**Butler Township Planning Commission  
Butler Township Municipal Building  
290 South Duffy Road  
August 3, 2021 @ 6:00 p.m.**

RE: Olivia J. Wiest Line Revision Review

RE: Diehl Volkswagon of Butler  
Land Development

RE: Diehl Volkswagon of Butler  
Stormwater Review

LOT LINE REVISION

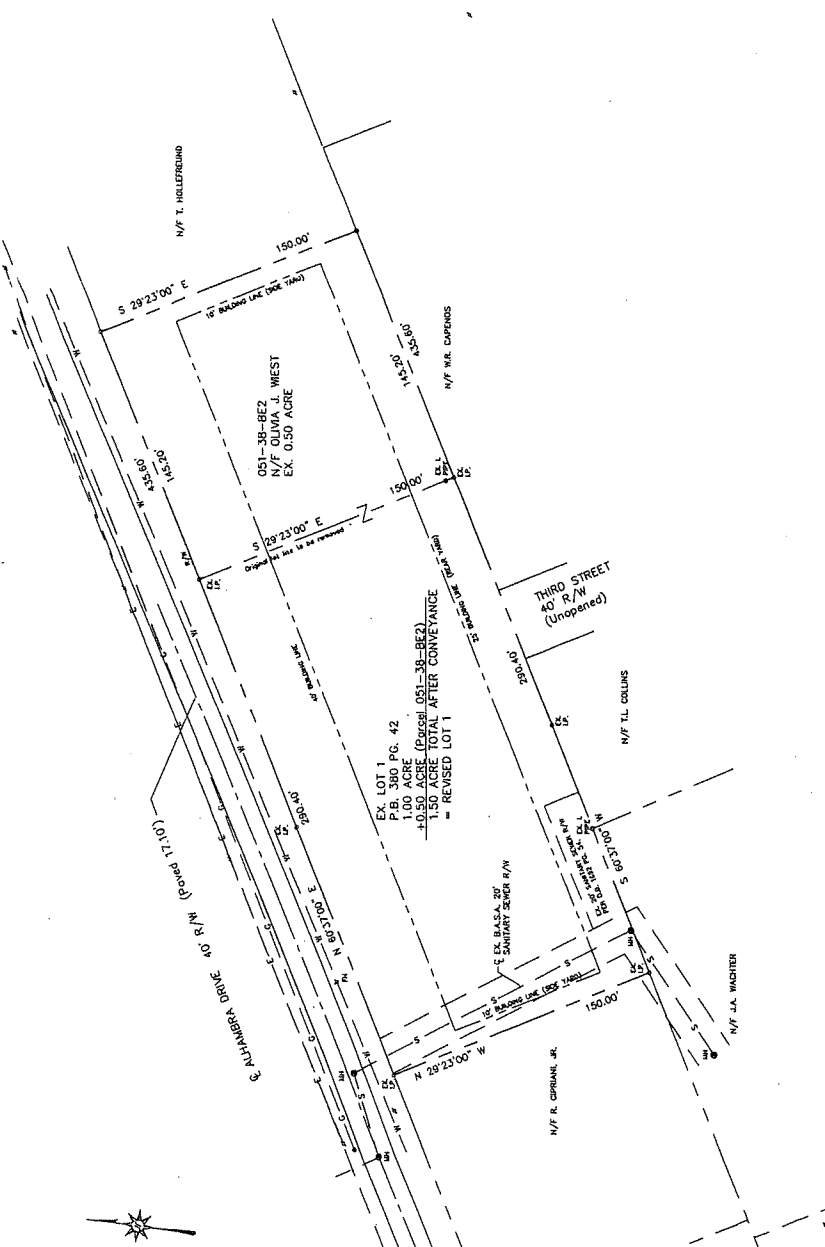
1. The Tax Parcel number for Ex. Lot 1 should be noted on the plan.
2. The Township may have additional comments.
